PLANNING COMMITTEE - WEDNESDAY 1ST JUNE, 2022

Planning Committee: 1st June 2022 **Late Representations/Information**

DC/2021/01739: 102 The Serpentine North, Blundellsands Liverpool L23 6TJ

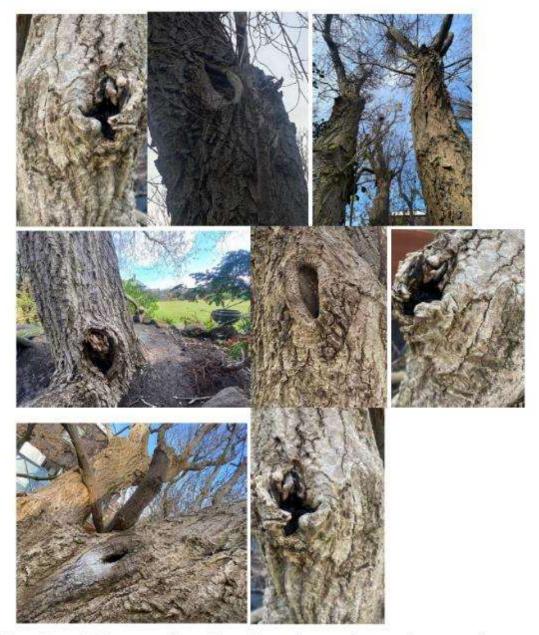
- I further attach the applicants original 'Site Plan' presented on the 21/7/2021 –
 incorrectly dated 2020 (Drawing No 686-01-B) which shows the garage wall
 again correctly at 6.9m according to the scale measure on this plan.

- 7. I attach the applicants' final same 'Site Plan' revised on 22/2/2022 (Drawing No. 686-01-B) and on which your assessment is based which shows the same existing garage wall to have suddenly extended in length. The length of this wall shown in this plan a FALSE MEASUREMENT now shown as 10m according to the scale measure provided. It is stated as 'Brick Wall retained and Lowered'.

As clearly shown above, the 'errors' (as with multiple other documentation advised to Sefton Council, always in the developers' favour) are on several different plans with earlier submissions correct and the final ones on which you are assessing the application to have been altered. I suggest this may be a deliberate attempt by the applicants to falsify the documentation knowing that to correctly show the garage wall as it is, the factually correct location of the trees and in their correct size (RPA, canopy and shading influence), the application would be unsupportable under policy, case law, best practice, guidance and Sefton Councils fiduciary duty.
